**CLINCH RIVER
BREEDER REACTOR PROJECT**

**PRELIMINARY
SAFETY ANALYSIS
REPORT**

VOLUME 20

Figure Q130.62-5A Horizontal Motion B SSE Ground Acceleration Time-History

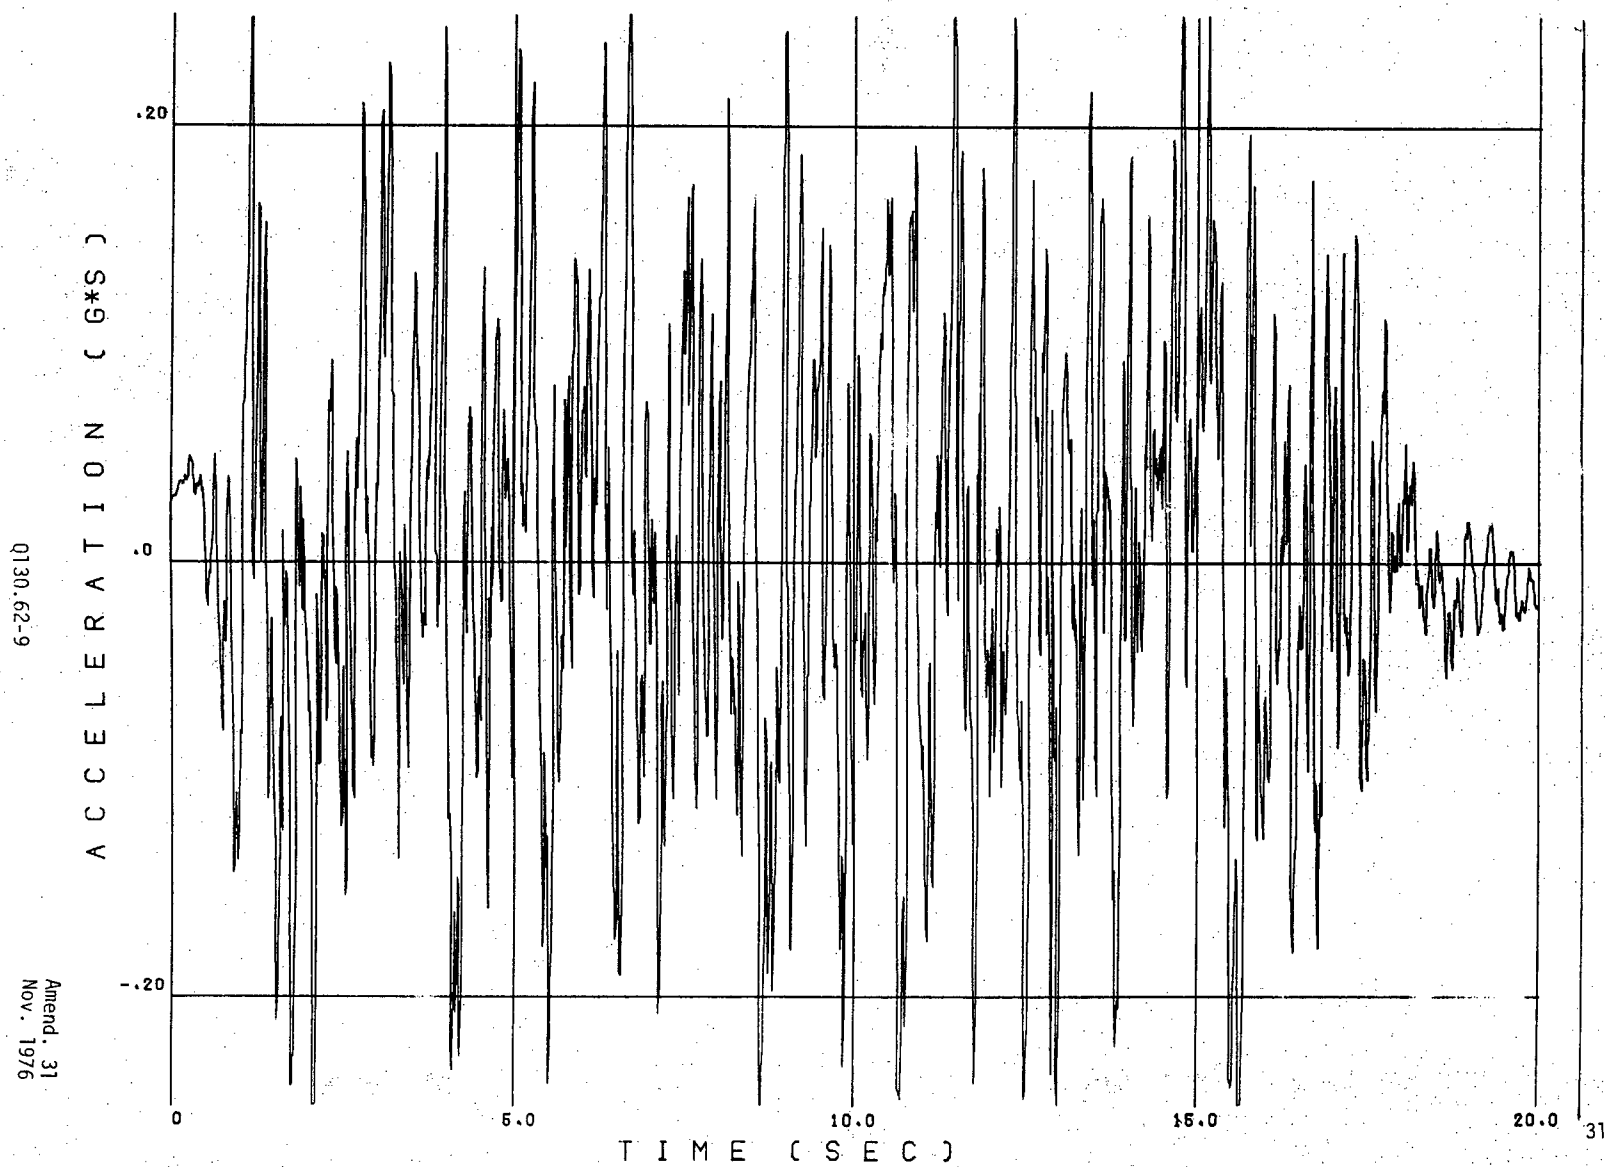
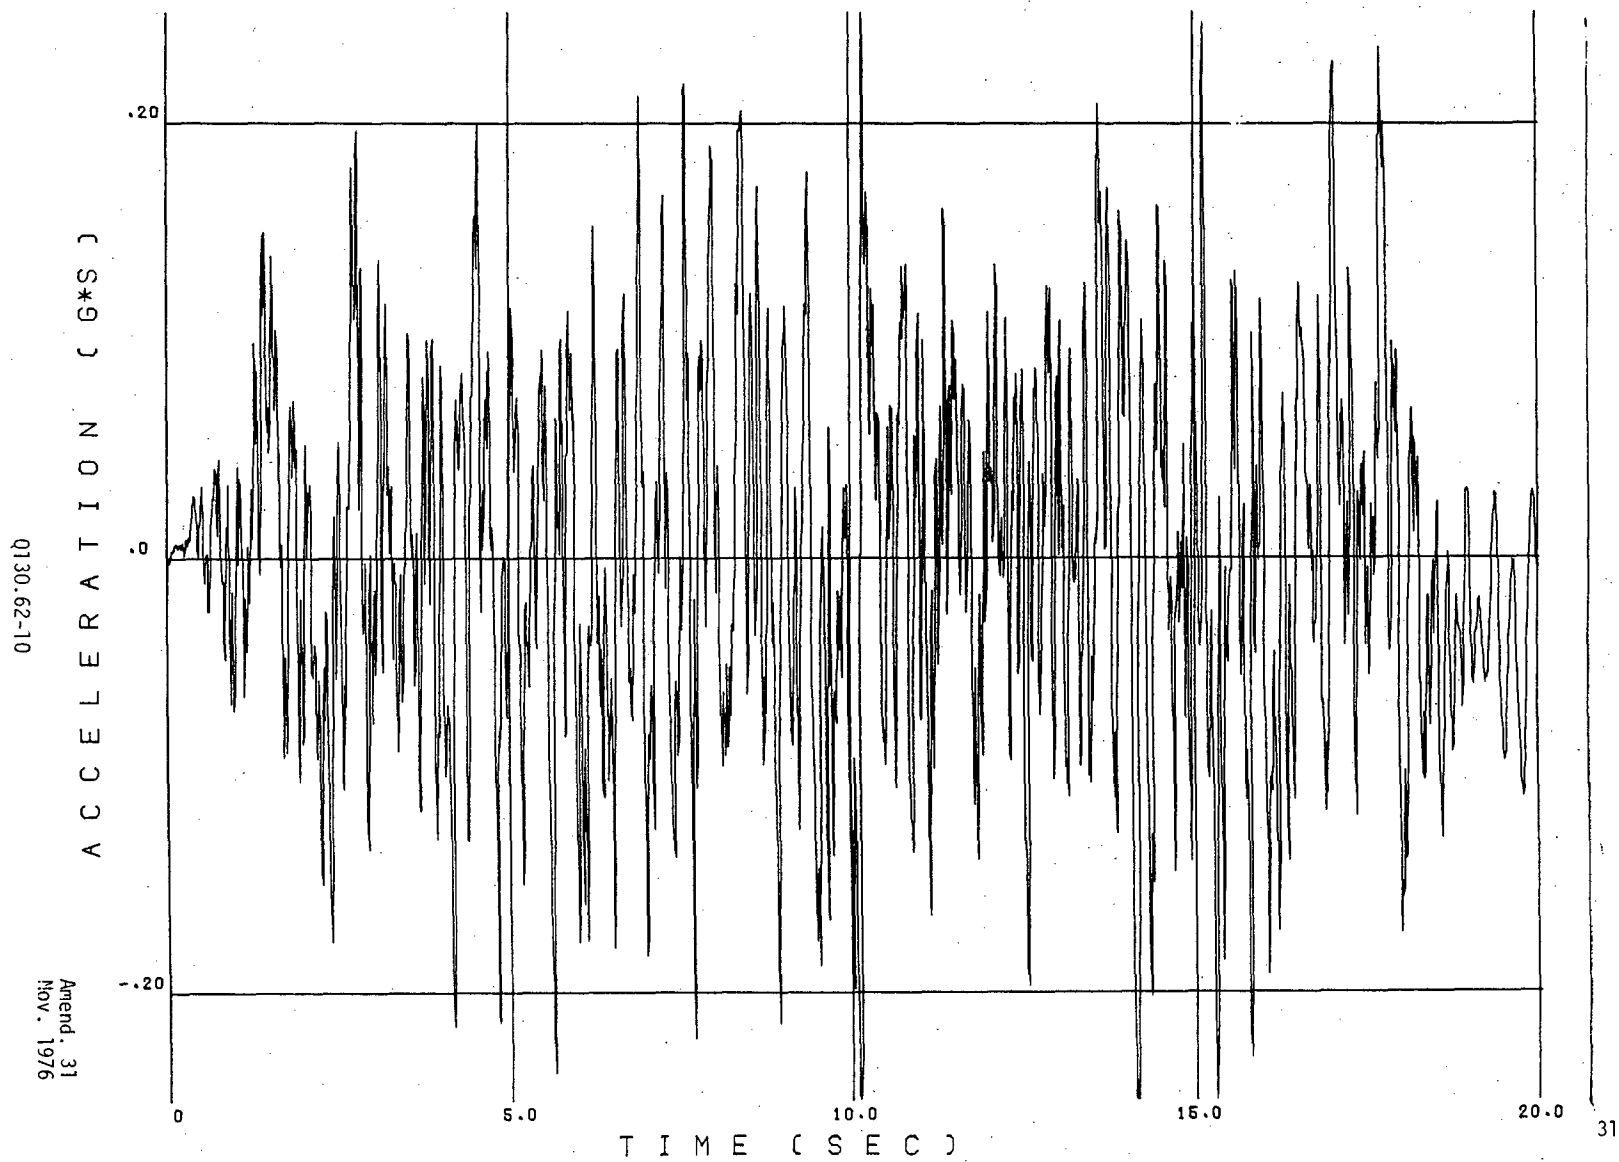
Figs. 3.7A-1, 2, 3, 4, 5 and 6 and Tables 3.7A-1 and -2 should be revised to comply with the 0.25 design ground acceleration value.
